Re: Response to First Determination of Completeness
FPL Sweatt-Whidden 230-kV Transmission Line Project
TLSA Application No. TA22-19
FDEP Case No. 22-1716
DOAH Case No. 22-1246TL

FLORIDA POWER & LIGHT COMPANY
SWEATT-WHIDDEN 230-kV TRANSMISSION LINE
TLSA APPLICATION NO. TA22-19
FDEP CASE NO. 22-1716
DOAH CASE NO. 22-1246TL
RESPONSES TO COMPLETENESS DETERMINATION
JUNE 8, 2022

Revised Figure 1-1

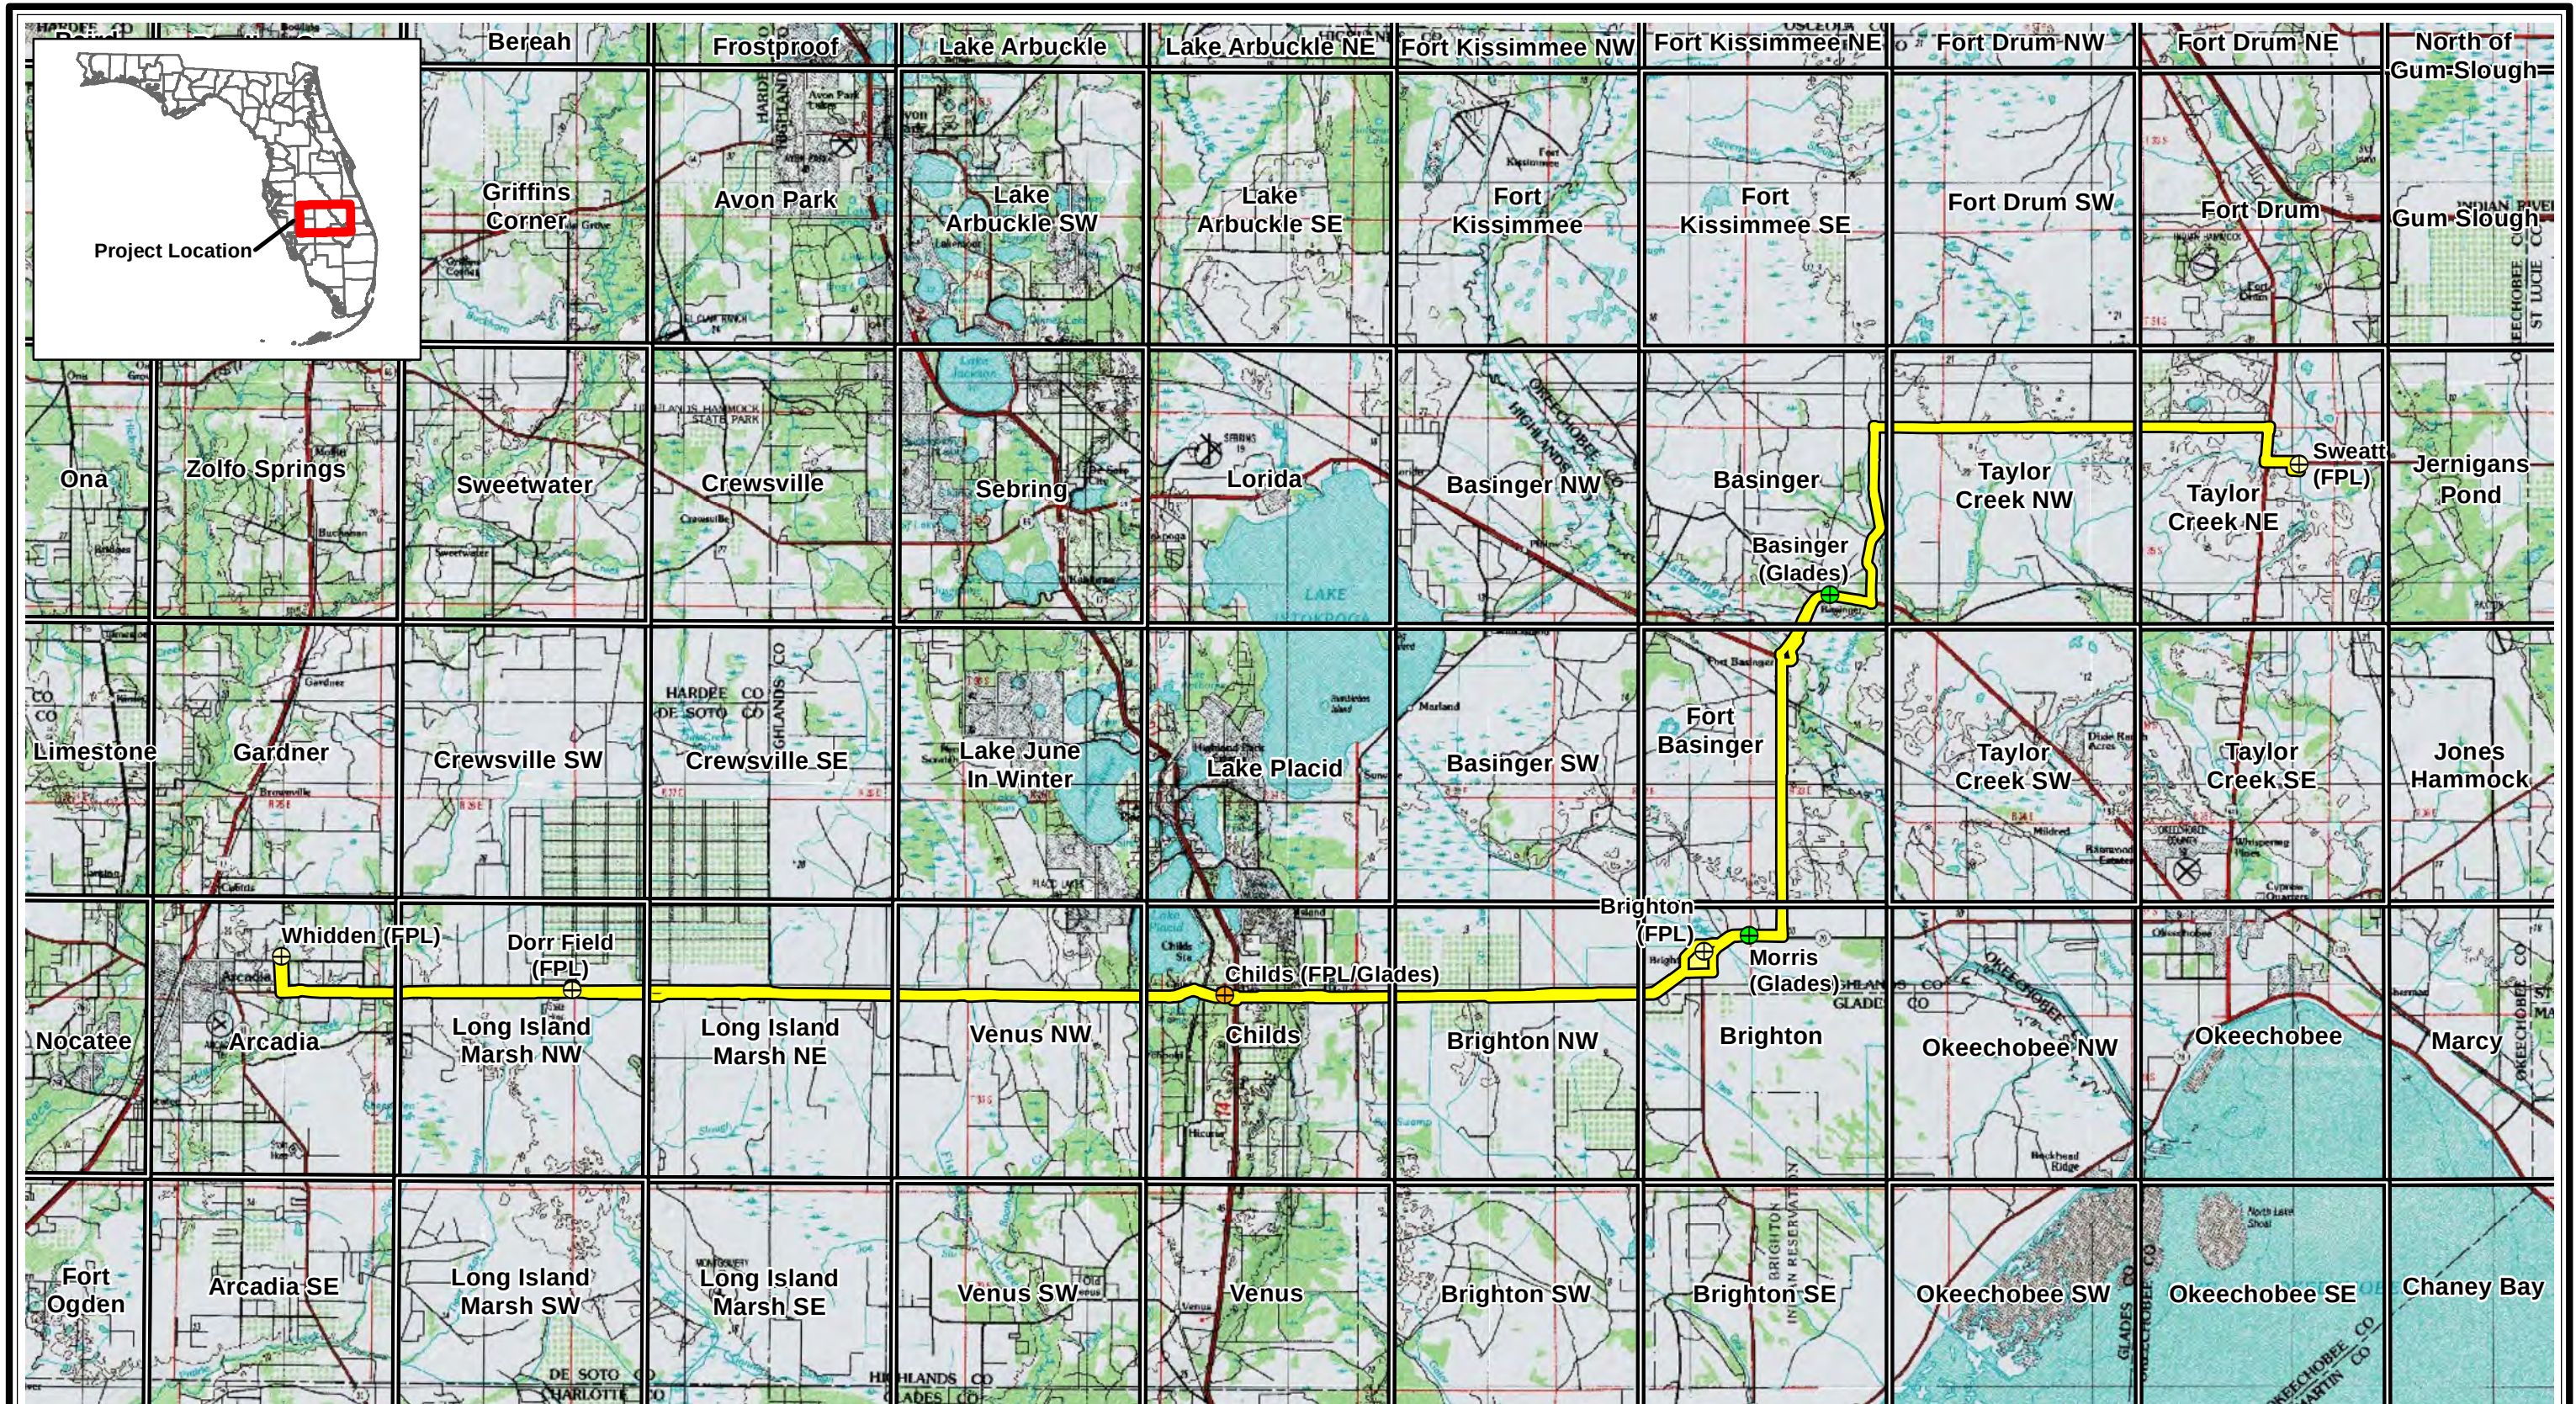
2. Please provide an additional map showing the project location within the state of Florida (Inset Map).

Refer to Attachment 2 for a revised location map showing the project location within the state of Florida.

Map Set of FPL Owned Parcels

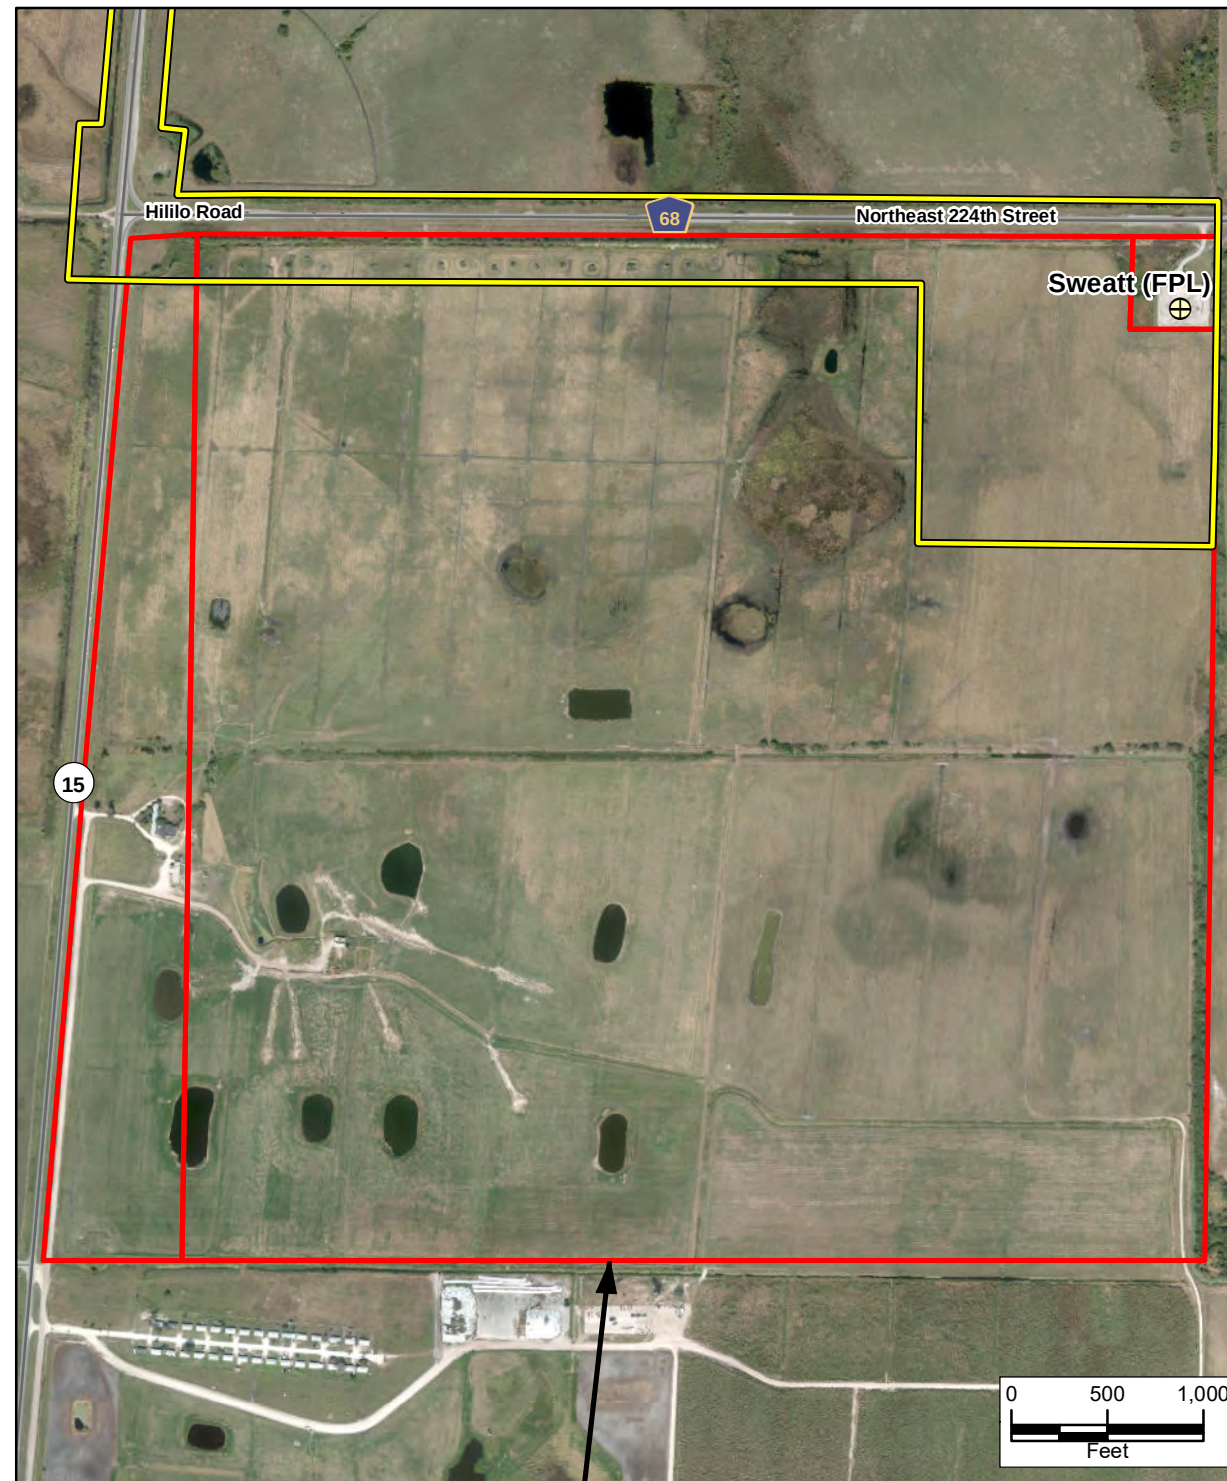
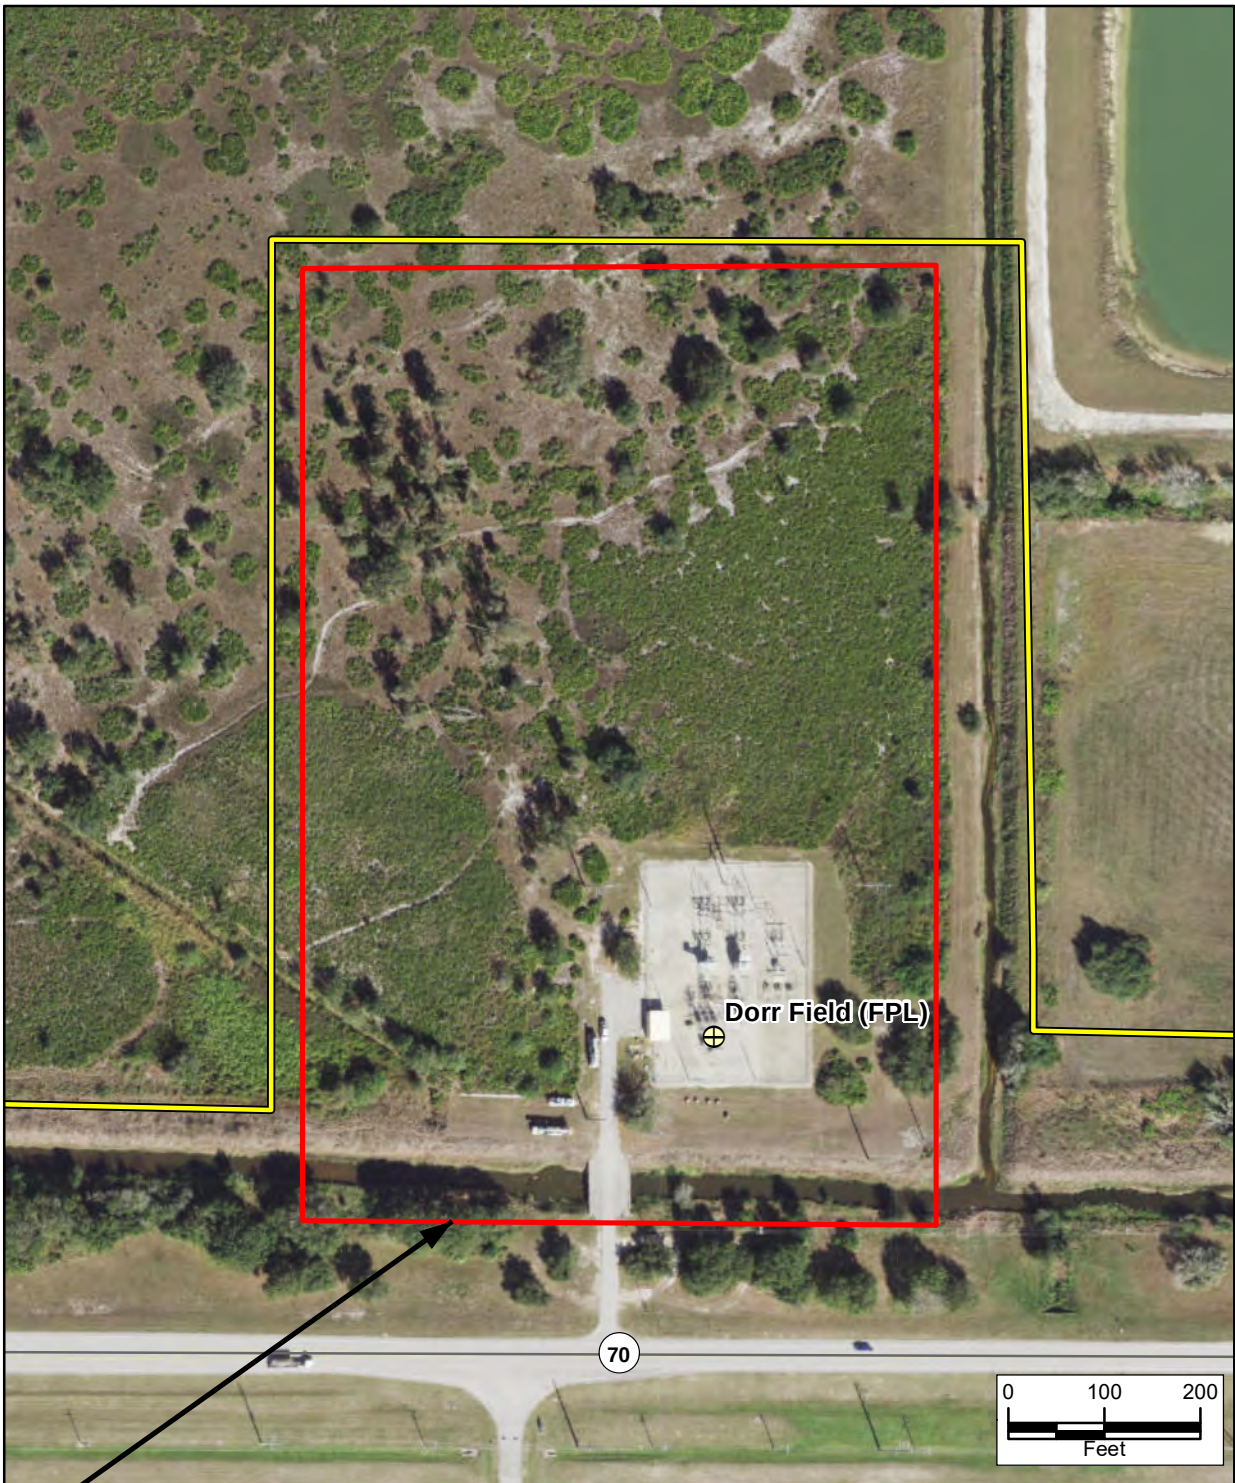
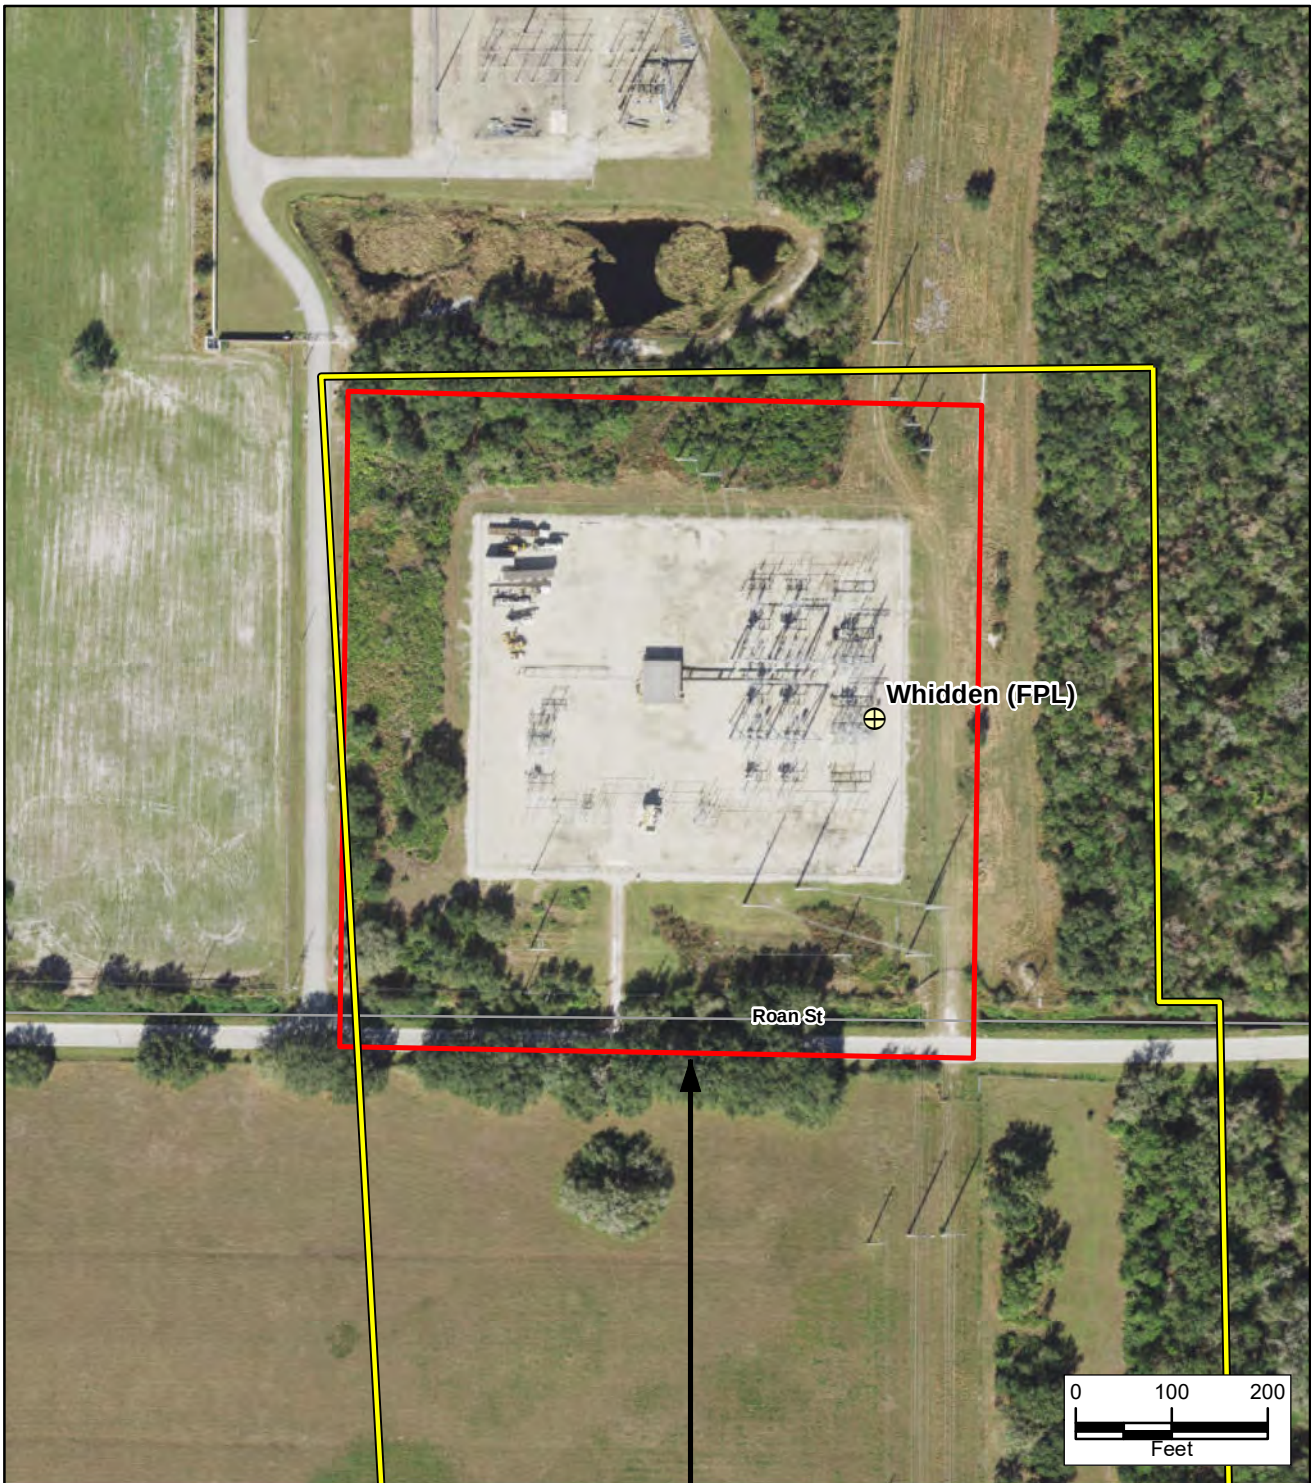
3. Only Figure 2-2 Map 1 (Map 1 of 35) shows an FPL Parcel Boundary as identified on the legend with a heavy black line. Are there any other FPL Parcel Boundaries on the other maps? If so, please identify more clearly.

Refer to Attachment 3 for a new map set showing all FPL-owned parcels along the Preferred Corridor. Specifically, the maps clearly identify a total of 6 FPL-owned parcels within the Preferred Corridor generally associated with FPL substations that are not part of this TLSA Application.
